# Stephenville Senior Citizens Center

Tree Preservation

# Certified Arborist Opinion

## Opinion - Ancient Live Oak

<b>Texas Department of Transportation</b>		<i>Austin District Standard</i>	
<b>TREE PROTECTION DETAILS</b>			
<b>TPD-19 (AUS)</b>			
©TxDOT 2020	CONT	SECT	HIGHWAY
REVISIONS		JOB	
06/16: SHEET CREATED			
04/19: APPROVED	DIST	COUNTY	SHEET NO.

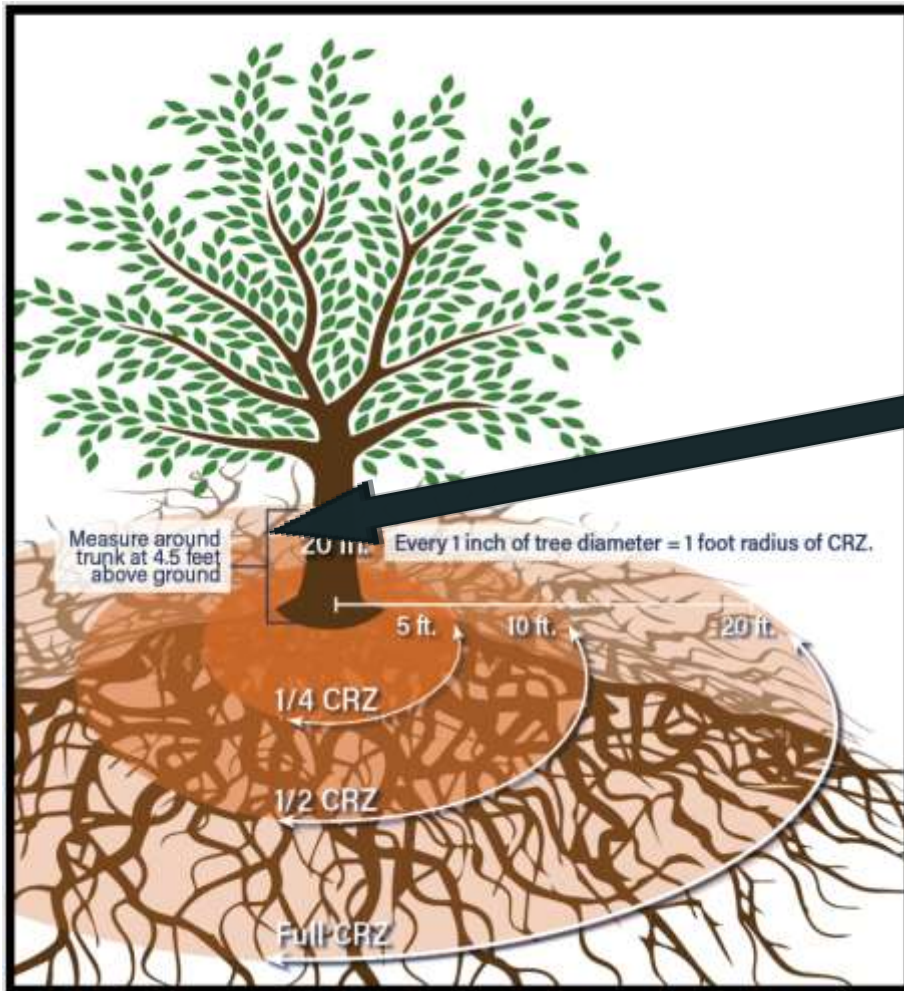
← **TxDOT guidelines indicate tree should be measured at a height of 4ft**

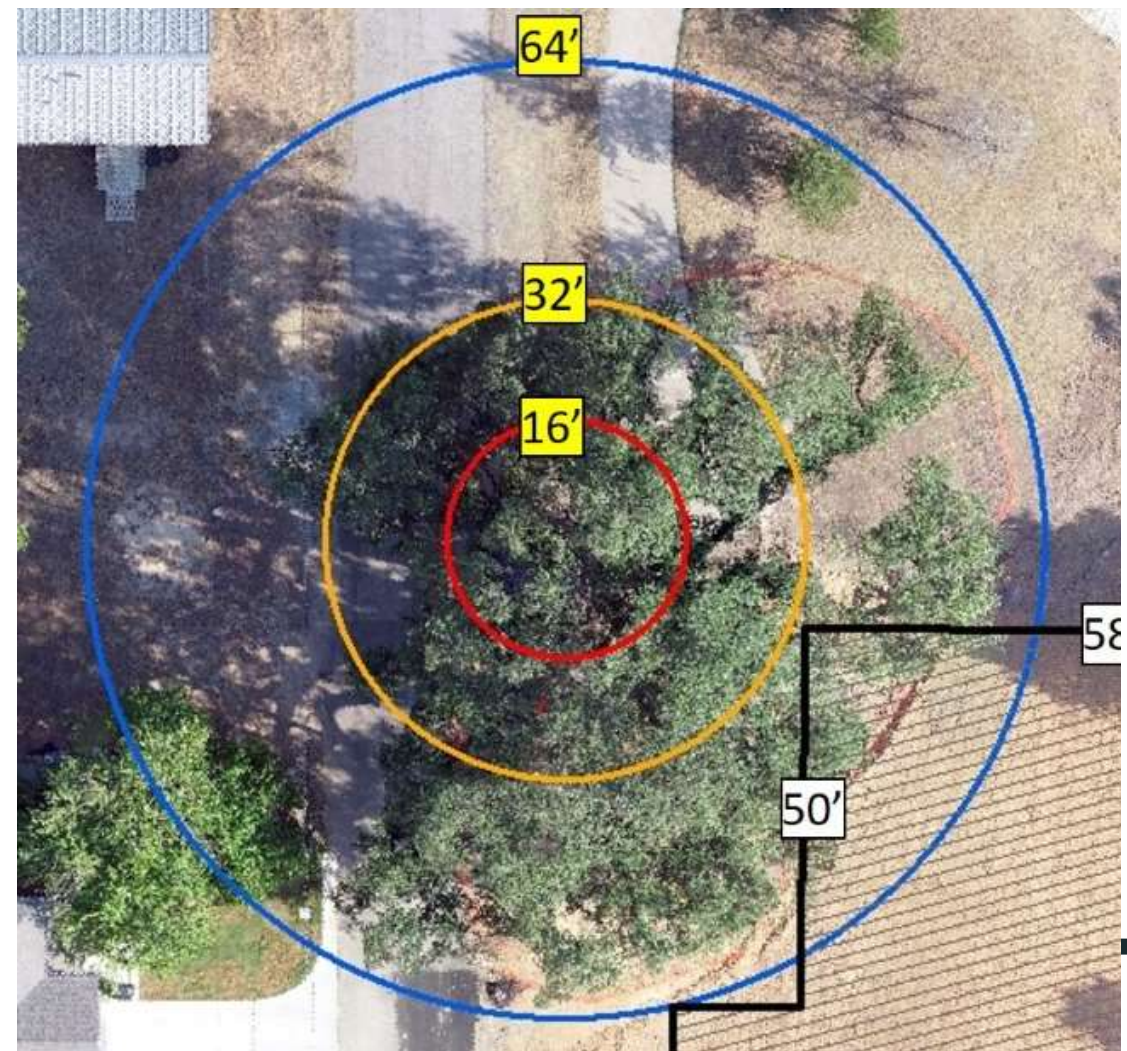
Proper measurement of the tree at 4 - 4 ½ ft above ground according to City of Austin building code and TxDOT tree preservation guidelines and Texas Forest Service practices.

Circumference = 201 in.

**Diameter = 64 in.**

Critical Root Zone = 64 ft.

$\frac{1}{2}$  CRZ = 32 ft.

$\frac{1}{4}$  CRZ = 16 ft.

**Building does not impact the  $\frac{1}{4}$  or  $\frac{1}{2}$  CRZs**

## Tree Preservation Criteria Best Practices from City of Austin Building Code

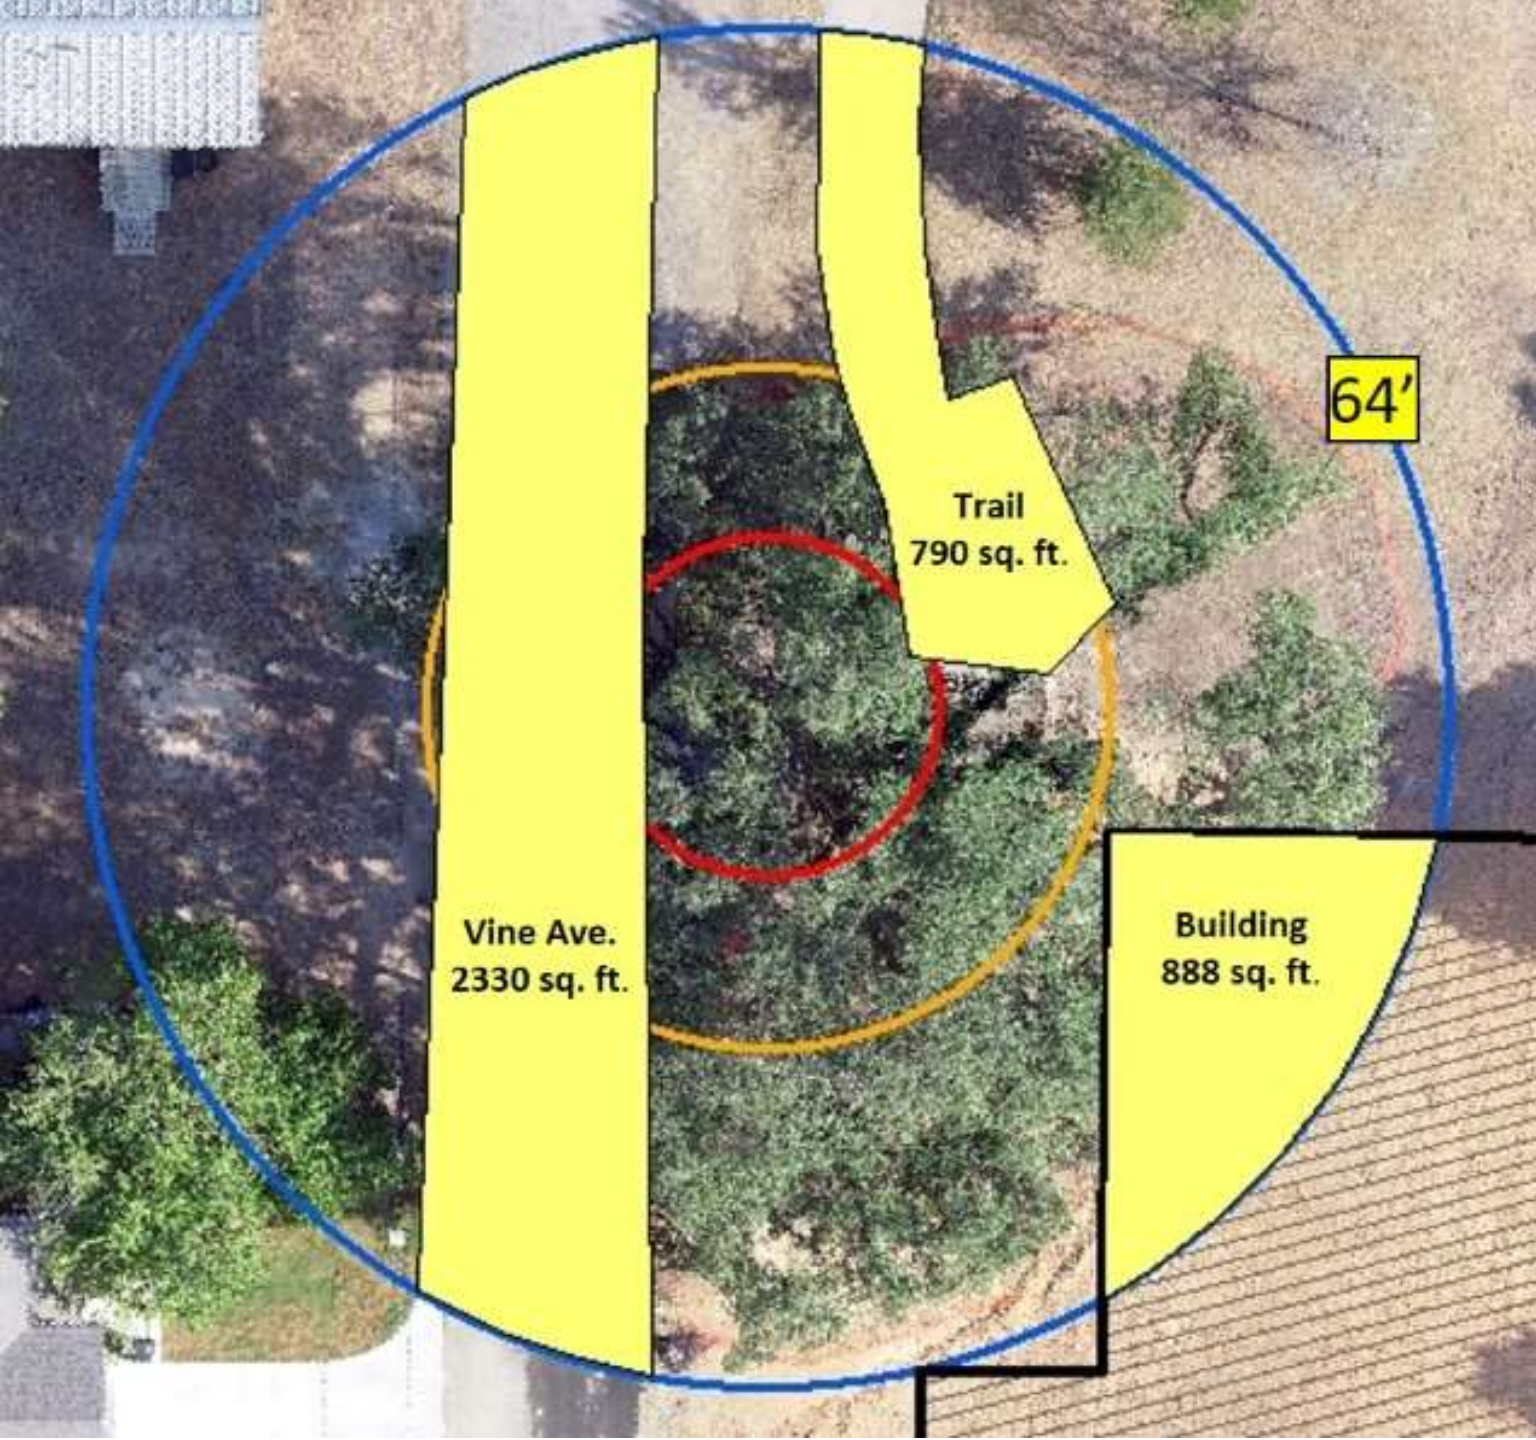
Most trees can tolerate some Critical Root Zone impacts. Impacts may be allowed as long as the following Preservation Criteria are met:

1. At least fifty percent of the total area (square footage) of the Critical Root Zone must be preserved at natural grade, with natural ground cover.
  2. The entirety of the Half CRZ must be protected, with the exception that cut or fill of 4" or less is allowed within the Half CRZ.
  3. No cut or fill is allowed within the Quarter CRZ.
-

**Total impact on CRZ,  
including existing  
roadway and  
sidewalks = 31%**

**Building placement meets exception guidelines to City of Austin Building Code**

- Building impacts no part of 1/4 CRZ
  - Building impacts no part of 1/2 CRZ
  - Total impact less than 50% of total CRZ
-

- Add 4" mulch within 16ft  $\frac{1}{4}$  CRZ
  - No more than 4" cut/fill within 32 ft  $\frac{1}{2}$  CRZ
  - Carefully remove any unnecessary fill dirt within the  $\frac{1}{2}$  CRZ
  - Construct 4ft rigid fence to ensure protection of 32ft  $\frac{1}{2}$  CRZ during construction process. Consider re-route of existing trailhead sidewalk to locate it outside  $\frac{1}{2}$  CRZ
  - Ensure street side parking on west side of building remains outside CRZ
  - Maintain natural grade wherever possible and evaluate drainage to ensure pooling does not occur within the CRZ
  - Hire a certified arborist to manage and supervise any canopy trimming necessary for construction of the building.
-
